# Release Note

## PD69100 Firmware Version 2.6.3

The following release note describes the firmware release (2.6.3) which is to be used on Microsemi Enhanced mode controller – the PD69100.

The release note describes the additions from previous release 2.6.0

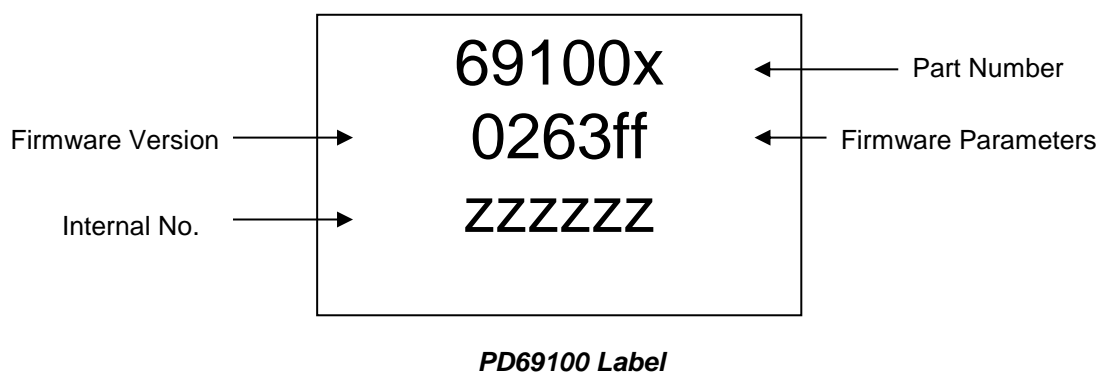
To order PD69100 with Rel 2.6.3 firmware, please mark "**PD69100x-0263ff**" in the purchase order. Where,

**x** stands for the default parameters setting as following:

- **C**: Detection Method = IEEE802.3at & Pre-standard
- **R**: Detection Method = IEEE802.3at
